STAFF RECOMMENDATION

NCPC File No. 6597

VIETNAM VETERANS MEMORIAL VISITORS CENTER

November 29, 2007

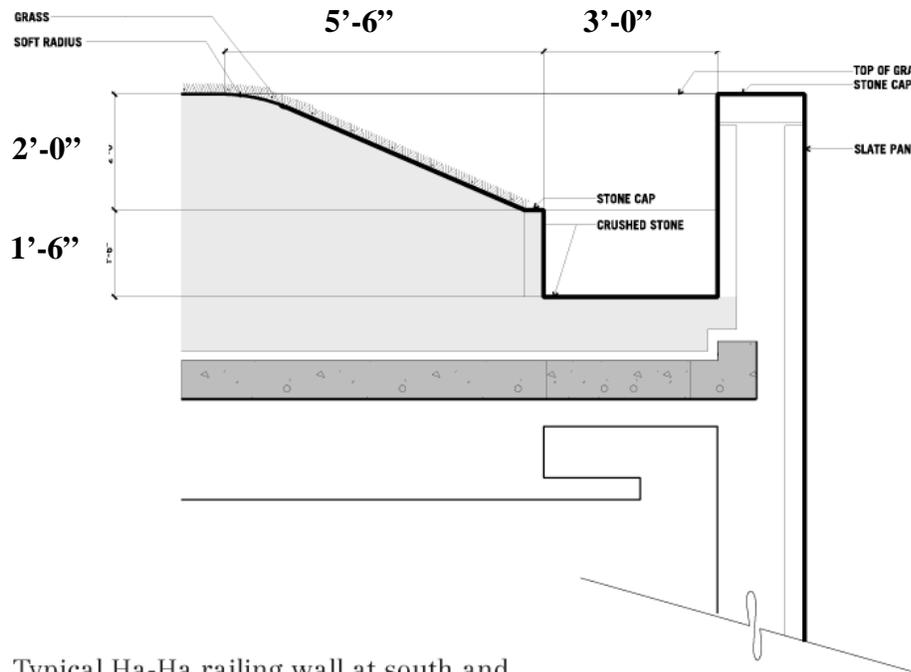
While the submission materials depict that the building is to be built underground, they also depict that some building elements are visible from the Lincoln Memorial steps and podium, from Constitution Avenue, and from within the axial view sheds of 23rd Street, NW and Henry Bacon Drive, NW. Project design revisions should reduce the scale of building openings and the protrusion of building elements that are visible from these areas.

Section DD - Through Entry Ramp Looking West Looking South
Scale 1/32"=1'-0"

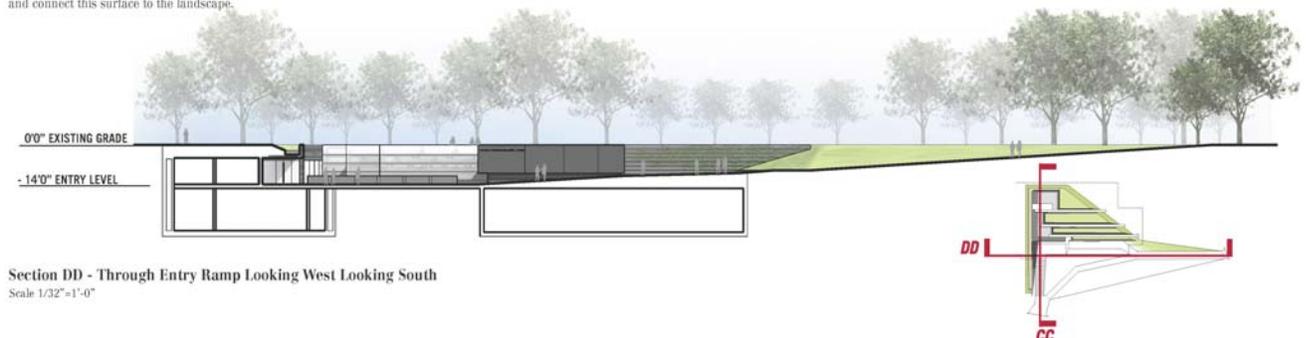
Staff concludes that the concept design maintains the existing grade. The entry is 14' below the existing grade with the courtyard floor at 31' below grade.

Concept design depicting proposed pedestrian circulation crossing locations to the Center from the Lincoln and Vietnam Veterans Memorial

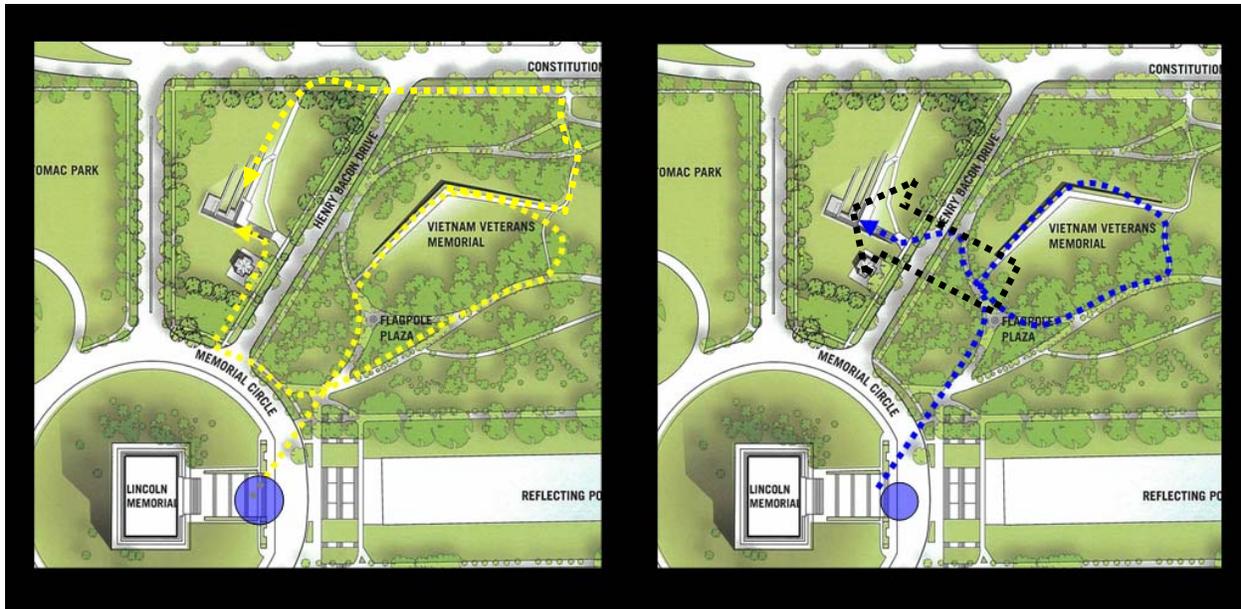
The applicant has not yet designed the project's pedestrian crossing points. Project pedestrian crossing points should be designed to meet this mitigation action. Pedestrians are likely to cross at the mid-block on Henry Bacon Drive. The District of Columbia Department of Transportation, in its comments on the site selection's Environmental Assessment, indicated that it required additional information on potential traffic impacts and also suggested that the National Park Service study an alternative mid-block pedestrian crossing point.

Existing tree drip line perimeter

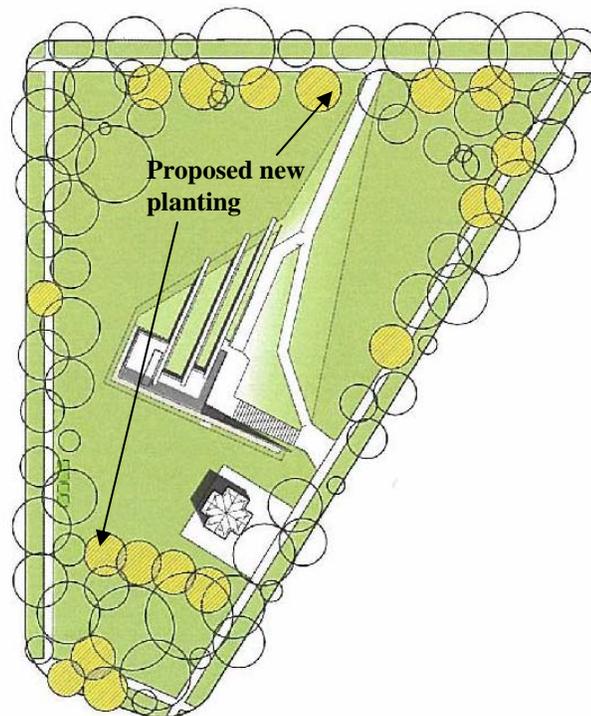
Additional environmental information is required to completely assess the impact of the Center to the critical root zone of the existing perimeter trees. Staff requests the NPS to provide actual survey data to confirm the location of the root zones during the preliminary design submission phase. The site is surrounded on its perimeter by mature elm trees that are part of the historic grounds of the Lincoln Memorial. Construction of a building on this site will require that heavy construction equipment pass among the trees during the construction period. It is imperative that the applicant protect these mature trees during construction and retain them following the construction period. Therefore design guidelines require all construction activity to occur outside of the critical root zone of these historic trees, and the applicant should develop a tree protection plan in accordance with standard construction procedures.

Proposed multi-purpose recreation areas

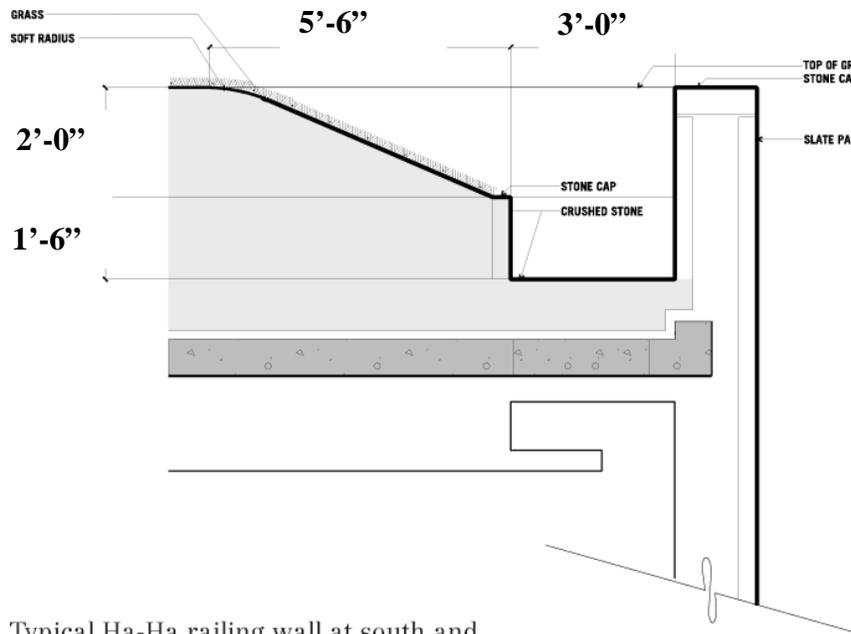
While an estimated 40% percent of the site will be available for multi-purpose recreation, the configuration of the space changes the nature of the landscape and limits the types of activities that can be conducted on the site. Staff requests that NPS provide additional information prior to preliminary design submission that demonstrates what activities can be accommodated on the site.

Typical Ha-Ha railing wall at south and west edges of courtyard

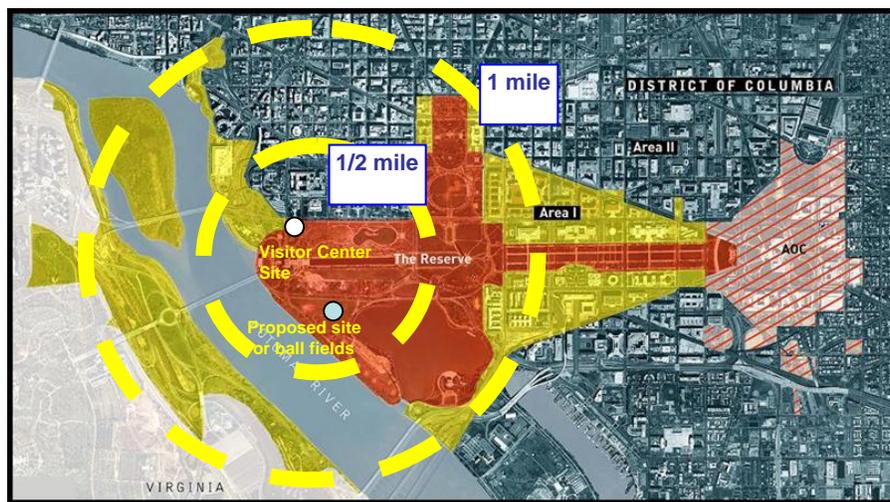
The submission states that the Visitor Center will be designed without guardrails or perimeter security elements. Project materials should demonstrate in greater detail how the sloped areas will eliminate the need for guard rails while ensuring pedestrian safety. The grade slopes down 2 feet to a 1 foot 6 inch deep by 3 foot wide well that meets the 2 foot, 6 inch high ha-ha wall (see image below). NPS should conduct further review and provide additional information to demonstrate how the sloped ground and ha-ha walls ensure pedestrian safety.

Map depicting location of proposed relocation of softball fields

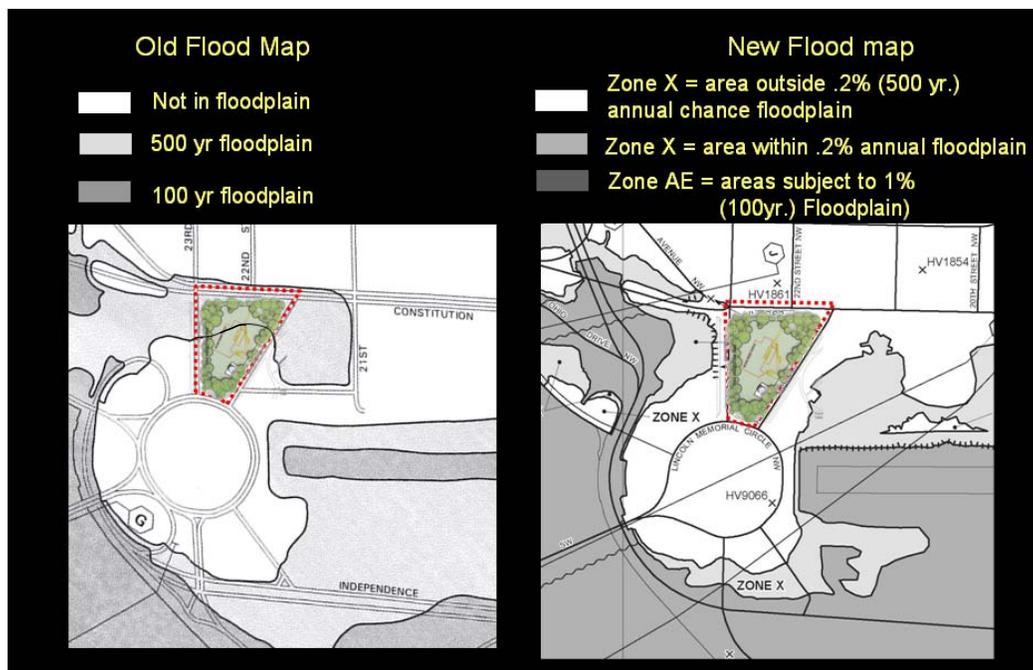
While NPS has indicated that it will seek to restore active recreation ball fields in the vicinity of the polo grounds located in West Potomac Park, NPS has not yet provided detailed information on this approach. Project materials should depict where these ball fields will be located in order to meet the mitigation action.
